Docket Number:	16-AAER-02
Project Title:	Appliance Efficiency Rulemaking for Computers, Computer Monitors, and Signage Displays
TN #:	214155
Document Title:	California Investor Owned Utilites Comments: CA IOU Response Electronic Displays
Description:	N/A
Filer:	System
Organization:	California Investor Owned Utilites
Submitter Role:	Public
Submission Date:	10/24/2016 1:03:18 PM
Docketed Date:	10/24/2016

CA IOU Response Electronic Displays Docket 16-AAER-02

Codes and Standards Enhancement (CASE) Initiative
For PY 2016: Title 20 Standards Development

Response to Proposed Regulatory Language for
Computer Monitors and Signage Displays

Figure 2.1: Nvidia G-Sync circuit board, with key components (processor and memory) labeled.

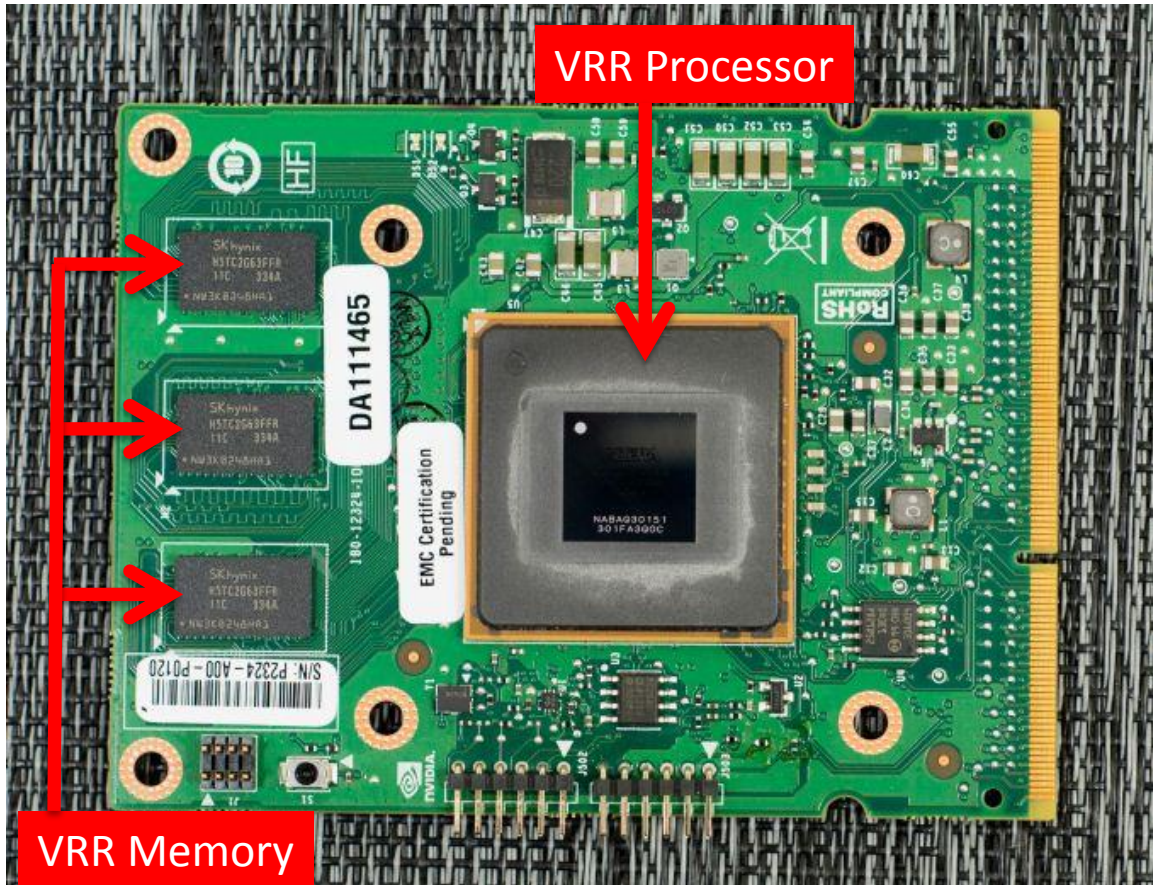
In this new definition, the phrase “an incremental hardware-based assistance” is used to distinguish a monitor with extra hardware dedicated to providing a variable refresh rate (VRR) from one that does not have additional. This phrase is ambiguous for a regulatory definition because it does not

specify exactly what additional hardware may count as VRR-specific. The hardware required in a monitor that uses this type of solution (e.g., an Nvidia G-Sync monitor) includes a dedicated processor that receives frames from the discrete graphics card in the attached gaming computer and dedicated memory that holds frames until they are to be displayed on the screen. Currently this solution is implemented on a dedicated circuit board, such as that shown in Figure 2.1.

To clarify what is meant by “incremental hardware” the CASE Team suggests the following changes (strike-through indicates deletion of original language, bold italics indicates additional language throughout this document):

“Gaming monitor” means a computer monitor that is capable of adjusting the monitor refresh rate with the frame rate of the video content, and supports a continuously variable refresh rate ranging across a factor of at least 1.75 times the minimum supported (for example a variable refresh rate of at least 40 Hz to 70 Hz if the minimum supported refresh rate is 40 Hz); ~~the monitor may include an incremental hardware-based assistance.~~ ***Hardware-based implementations include a dedicated processor that receives frames from the discrete graphics card in the attached computer and dedicated memory that stores frames.***

Figure 4.1 Uptake of ENERGY STAR: Historical

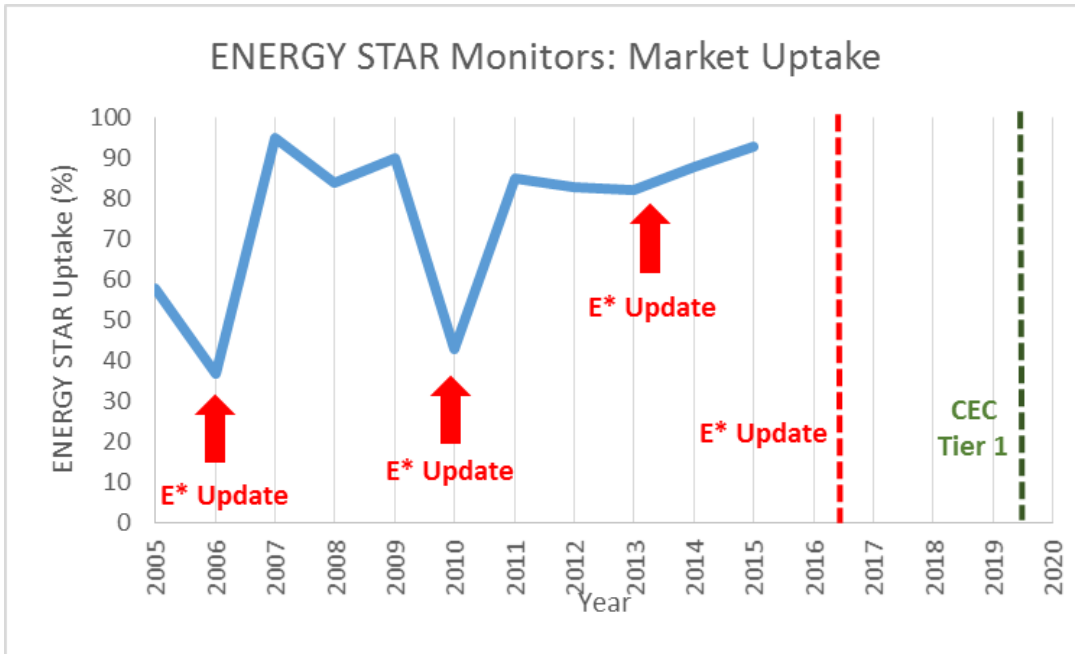
Figure 4.1 shows the historically rapid uptake of the ENERGY STAR monitor specification. In the three specification revisions since 2005, **over 80%** of the market has met the ENERGY STAR specification by Year 2. Assuming past trends continue, the CASE Team projects high market adoption of the Version 7 specification by July 2019, the proposed effective date of the Tier 1 standard. **CEC On Mode levels are similar or less stringent than the ENERGY STAR Version 7 specification before the application of any CEC proposed adders in almost every case,** as shown in Figure 4.2. Given past ENERGY STAR uptake rates and the On Mode allowances proposed by CEC, the CASE Team anticipates most of the market will already be meeting the CEC levels without any additional modifications by the effective date.

Figure 4.3 EPDs: Comparisons of ENERGY STAR Versions 7 and CEC Tier 1 Levels

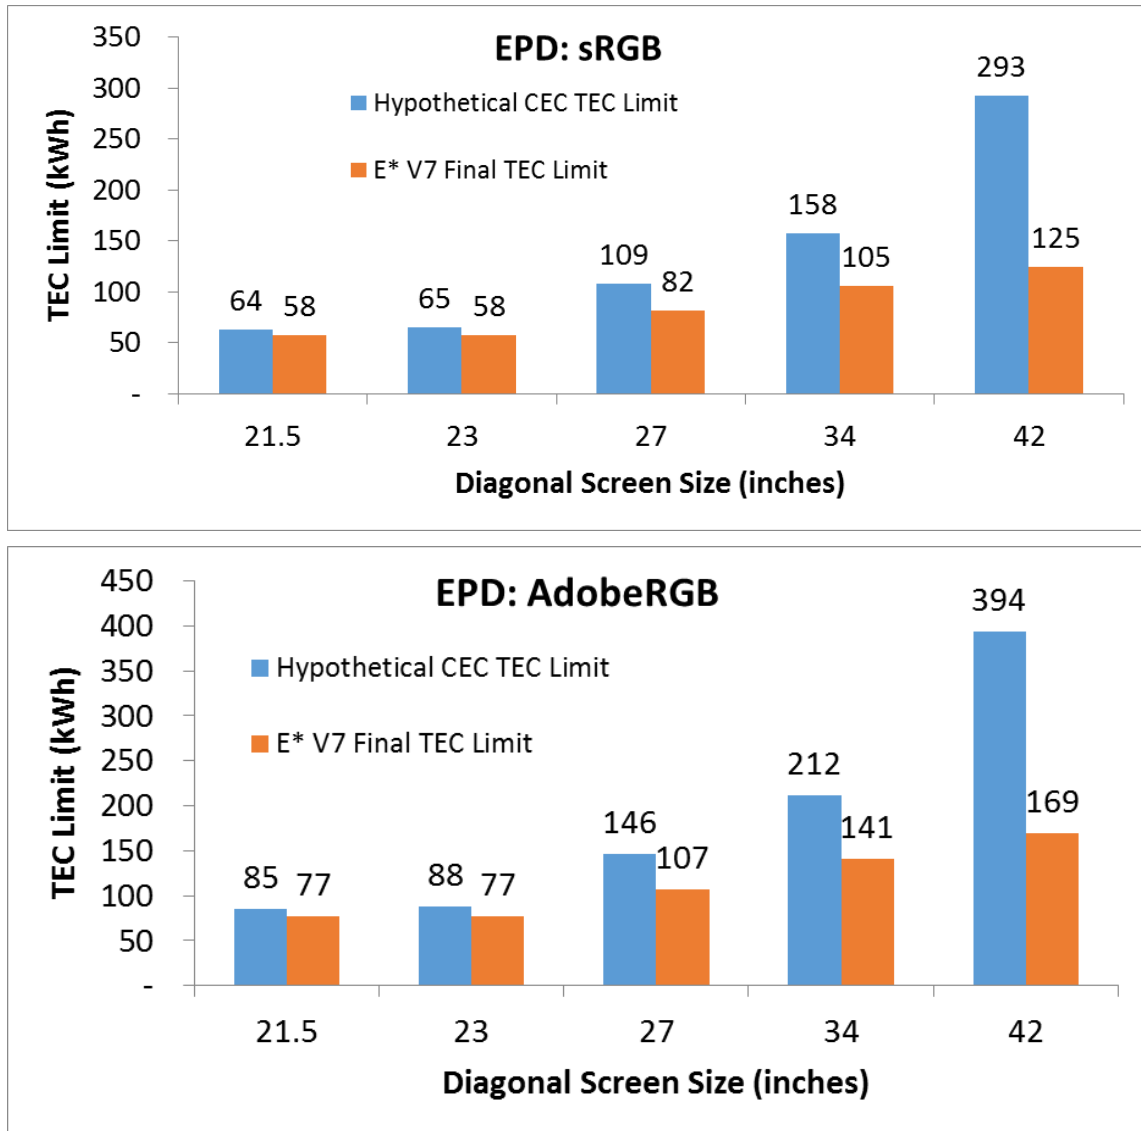
In the Express Terms, CEC increased the EPD adders proposed in the April 2016 Staff Report from 10% to 30% for sRGB monitors and from 50% to 75% for Adobe RGB in Tier 1. Table 4.1 and Figure 4.3 compare the updated CEC proposal for EPDs with the ENERGY STAR Version 7 specification that recently took effect in July 2016. In order to compare the ENERGY STAR specification, which uses a Typical Energy Consumption (TEC) value, with CEC’s modal power approach, we used the same duty cycle assumptions as ENERGY STAR to calculate a hypothetical CEC TEC value. Please note that at the largest sizes, the CEC proposed On Mode allowances for EPDs is over double the allowance provided by ENERGY STAR. Given most of the monitor market will meet the ENERGY STAR Version 7 regulation by the July 1, 2019 effective date, **the CEC limit of applying a single adder is more than sufficient for EPDs to meet the proposed regulation.**

Figure 4.4 On Mode Level for 20-in Monitors

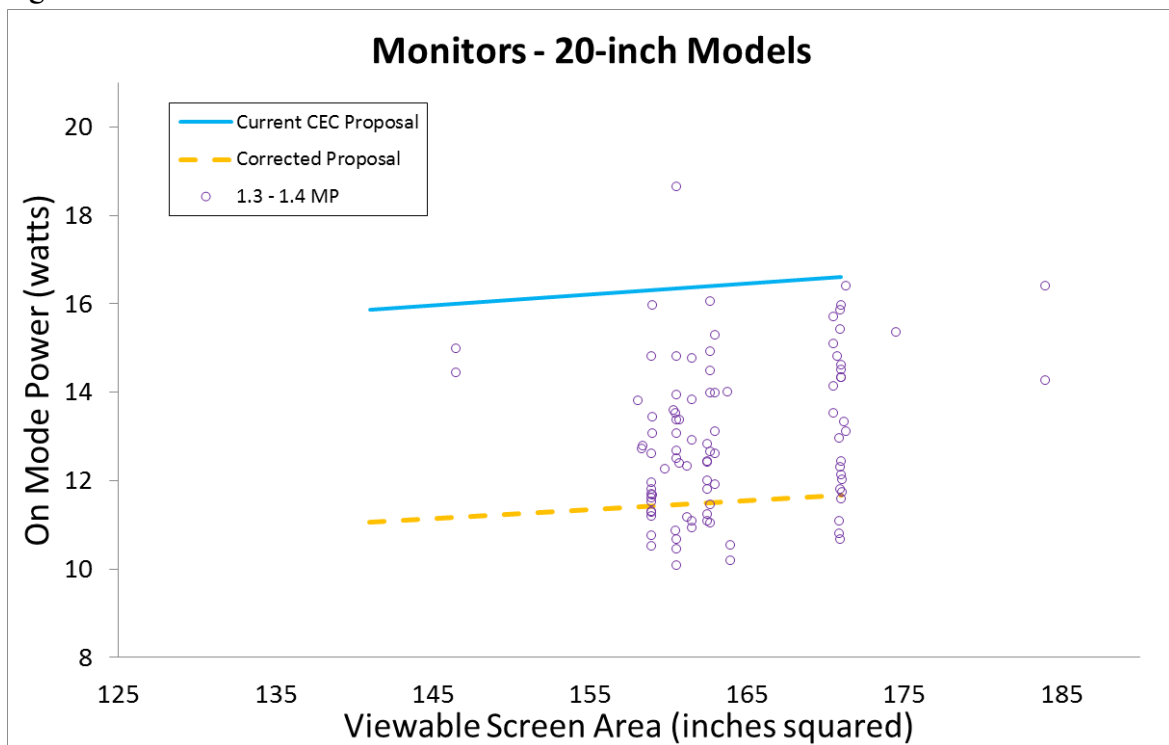
We believe CEC should make a correction in Table V-4. For consistency among the size bins, the following should be corrected in Table V-4 for both the regular resolution (≤ 5 MP) sizes and the high resolution (> 5 MP) sizes as shown in Table 4.3. Currently, if 20-inch monitors are subject to the On Mode requirements in the lowest size bin, based from the ENERGY STAR Version 6 requirements, all 20-inch models that were manufactured since 2012 would be able to meet the level with no modifications necessary as shown in Figure 4.4. This would mean that there will be no savings for consumers associated with these models. Given that all 20-inch models would meet the current CEC proposal and given that there are cost effective strategies available today for these models to be more efficient, the CASE Team recommends CEC update current screen size bins according to Table 4.3.

Figure 4.5 On Mode Allowance for Resolution

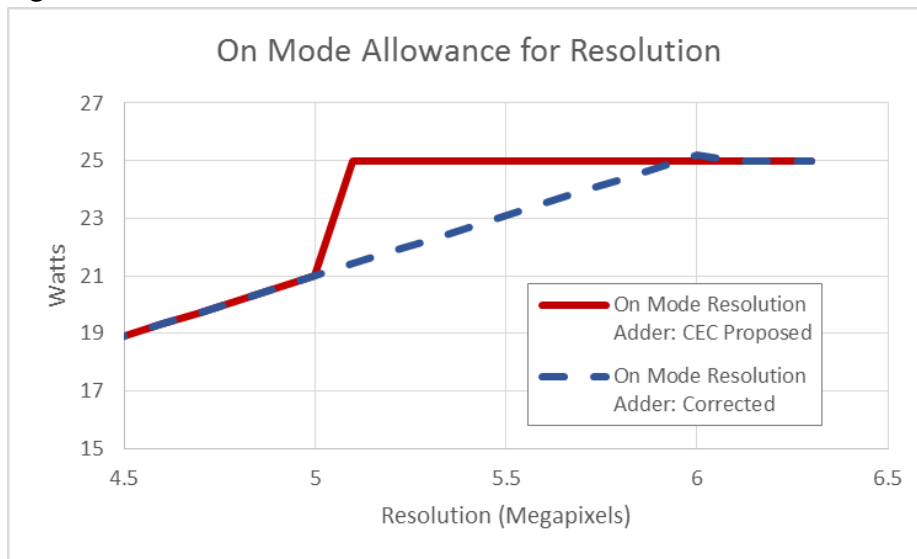
We believe there is another correction needed in Table V-4 in the Express Terms (and corresponding Table 15 of the Staff Report). For higher resolution monitors, in previous drafts, CEC proposed an equation that did not include resolution as a variable in the On Mode power allowances similar to the current proposal in Table V-4.¹ However, for these high resolution models, in previous drafts CEC proposed a constant 21 Watt (W) allowance in the equation regardless of resolution. We understand that the constant term was determined by multiplying 4.2 by 5.0 (the megapixel [MP] resolution that was the cutoff at the time). This way, there would be a

gradual increase in the resolution adder up to a certain resolution. In the Express Terms, CEC proposes the same resolution cutoff (i.e., 5.0 MP) but increased the constant allowance to 25 W. **Keeping the equation as-is would mean that models with a resolution between 5.0 MP to 6.0MP could get an additional allowance of up to 20%, which would be in effect another adder.** Refer to the examples outlined below in Table 4.4 and Figure 4.5.

In order to keep the same gradual increase in the resolution adder and prevent a step-wise jump, the CASE Team recommends the following solution to clear up this potential area for confusion. CEC should modify Table V-4 to read “Resolution ≤ 6.0 MP” and “Resolution > 6.0 MP”. Incorporating this correction would mean monitors would get **gradual** increase in On Mode allowance by resolution instead of a significant jump in allowance. This would be consistent with the equations since 4.2 multiplied by 6.0 is 25, which is the new constant in the equations for higher resolution monitors. It is not clear if this was CEC’s intention, but the CASE Team notes the resolution cap was raised to 6.0 MP for integrated displays.
